SUBJECT: DRAFT SITE CHARACTERIZATION ANALYSIS ON BWIP SCR  
OPS PLAN NO. 311221E

**SITE CHARACTERIZATION ANALYSIS**

THE U.S. DEPARTMENT OF ENERGY  
SITE CHARACTERIZATION REPORT  
FOR THE  
HIGHTWATER WASTE ISOLATION PROJECT

Figure 1. DOE's Conceptual Model of Groundwater Flow.

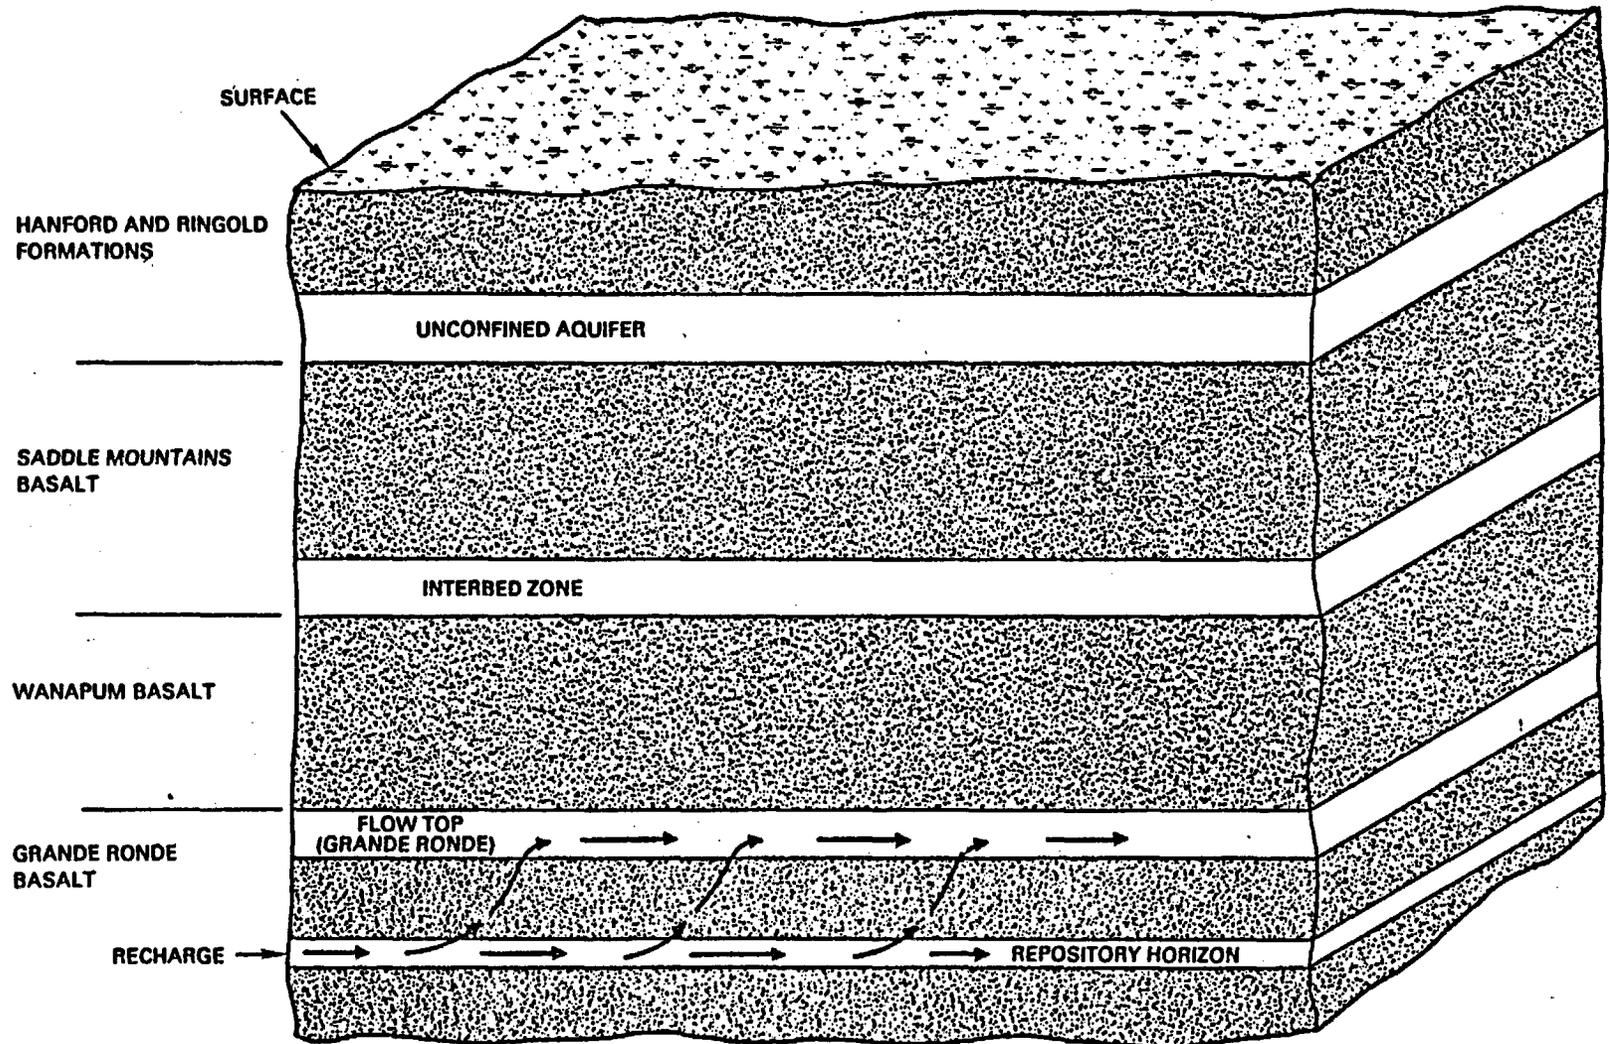
The conceptual groundwater model presented in the SCR is based essentially on a geologic system that consists of areally continuous, layered basalt flows and interbeds of the Columbia River Basalt Group (Figure 1). The main features of this model are that the flow systems are layered and confined, with interbeds and flow tops acting as homogeneous aquifers and low-permeability columnar basalt zones acting as homogeneous confining layers. Horizontal and vertical hydraulic gradients are interpreted to be minimal. While DOE recognizes that vertical leakage potentially occurs across flow interiors, strong assertions are made that little vertical flow occurs between shallow and deep flow systems in undeformed areas. Apparent breaks in key hydrochemical parameters are interpreted by DOE to indicate separation of shallow and deep flow system. While

small-scale structural and stratigraphic discontinuities that are spaced meters to tens of meters apart in the Umtanum Flow at the Emerson Nipple Section. Figure 3, a reproduction of SCR Figure 3-52 (page 3.7-29), shows the areal distribution of aeromagnetic anomalies which are interpreted by the BWIP staff as expressions of significant structural features in the subsurface. Many of these features correlate exactly with the trace of major structural features; other features are uncharacterized to date. Irregularities in the distribution of basalts illustrated in the "Top-of-Basalt Contour Map" (SCR Figure 3-51) may well be related to significant stratigraphic discontinuities. Structural discontinuities in the Pasco Basin exist at a variety of scales, from extensive zones of major structural influence (e.g., faulting and fracturing along the Gable Mountain-Umtanum Ridge anticline), through more discrete zones of offset (e.g., the "Nancy Linear"), to small-scale (mm to 1m) tectonic breccias, radiating fans, and cooling joints, which may be spaced meters to tens of meters apart. Stratigraphic discontinuities apparently range in scale from major pinch-outs of basalt flows and sedimentary interbeds to local thickening and thinning of flow-top breccias. The variety and ubiquity of structural and stratigraphic discontinuities apparent in Figure 2 contradict the simplicity of structure and stratigraphy shown in Figure 1, which represents the DOE's conceptual and numerical models.

Figure A-10

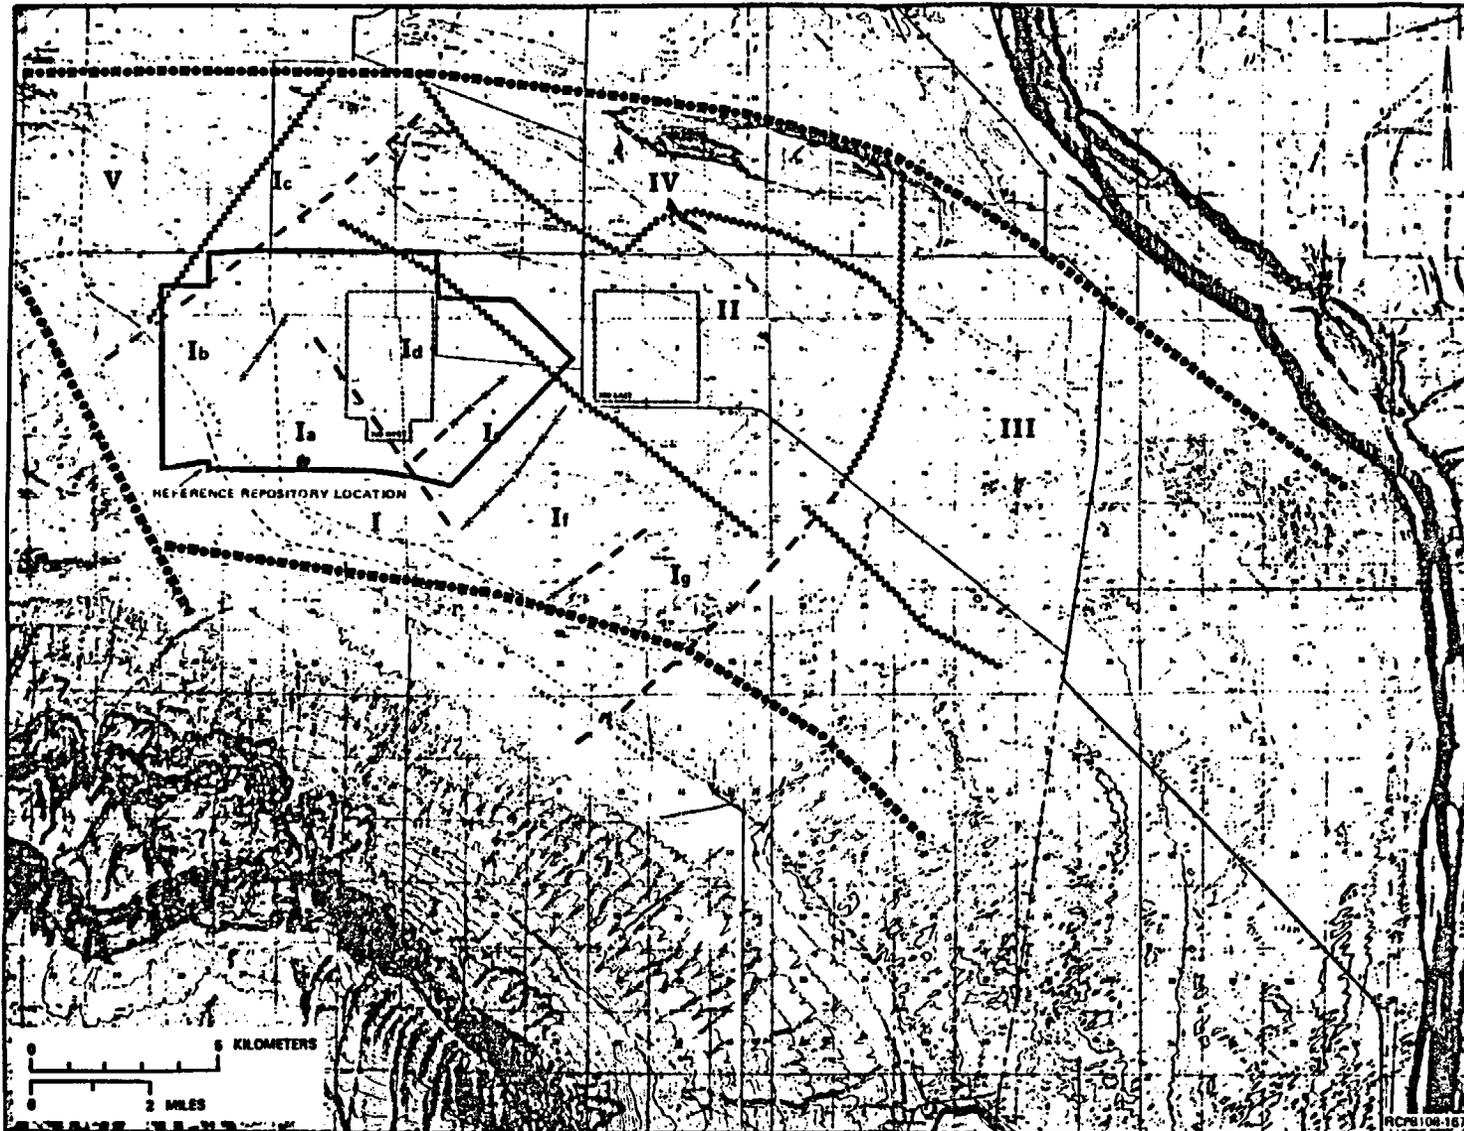
In addition, the DOE should consider that the intact volumes of rock (Appendix A, Figure A.10) discussed by C.W. Meyers in RHO-BWI-ST-14 are far more complex in structure than is indicated in the SCR. These intact volumes of rock are described in the SCR on page 3.7-28, paragraph one. Five lines of reasoning support the NRC's concern:
